PRE-APPLICATION CONFERENCE NOTES
Parmentier Short Plat (File # 2021-029-PAC)

Site Address	1440 Aspen Ave, La Center WA 98629
Parcel Numbers:	258895000
Applicant	Edward/Julie Parmentier 1440 Aspen Ave, La Center WA 98629 Email: eiparm@tds.net Contact number 360-263-2236
Applicant's Representative	Same as applicant
Property Owner	Same as applicant
Proposal	The applicant proposes to divide the existing lot into two lots. The applicant's proposal would create a 7,500 square foot lot in the northeast corner of the existing lot. Division into two lots is reviewed under the short plat process, a Type II review process under LCMC 18.205.020. A short plat requires a pre-application review but does not require a public hearing.
Meeting Date	Wednesday, August 18, 2021 at 3:00 p.m.
Date of Issue	August 27, 2021

LA CENTER SANITARY SEWER SYSTEM - 2020

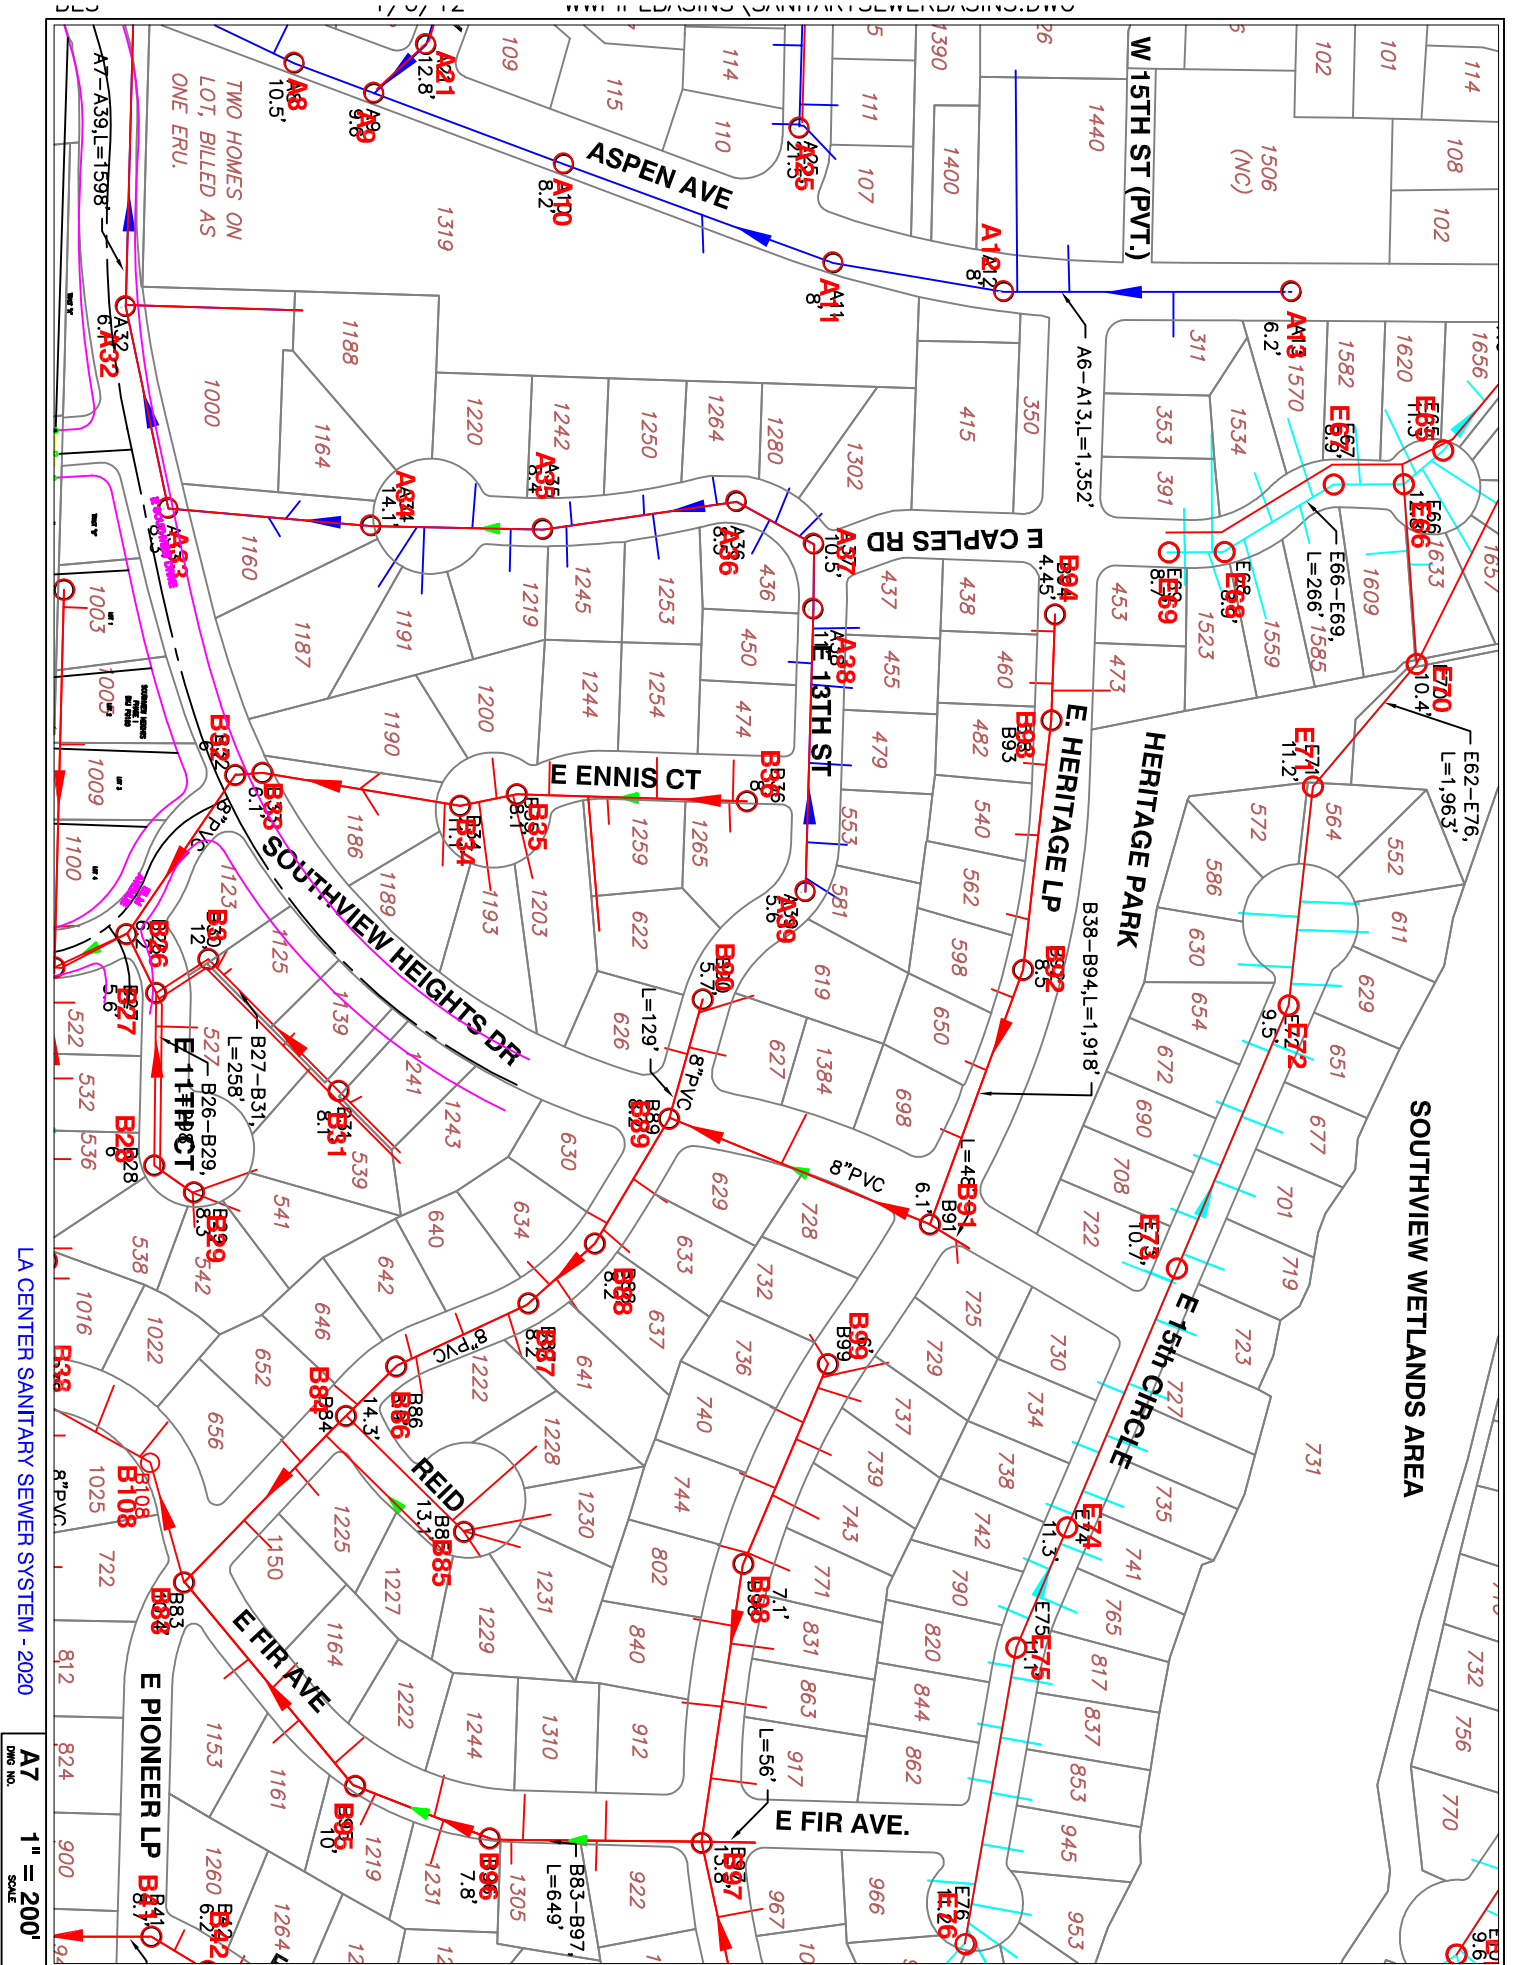
The sewer mapping shows there is an existing sewer lateral stub to 1440 Aspen. Likely this is a 4” diameter service lateral. The LCMC 13.10.110 (2) requires that “A separate and independent side sewer shall be provided for every building, if one building is at the rear of another under the same ownership, and no private sewer is available”. There are two options: (1) Replace the existing 4-inch sewer lateral with a new 6-inch diameter lateral from the 8-inch public sewer in Aspen Avenue to the property line, and then extend separate 4-inch diameter laterals to the existing house at 1440 Aspen Avenue and the new lot or (2) Install a new 4-inch lateral to the new lot from the 8-inch sewer main in Aspen Avenue.
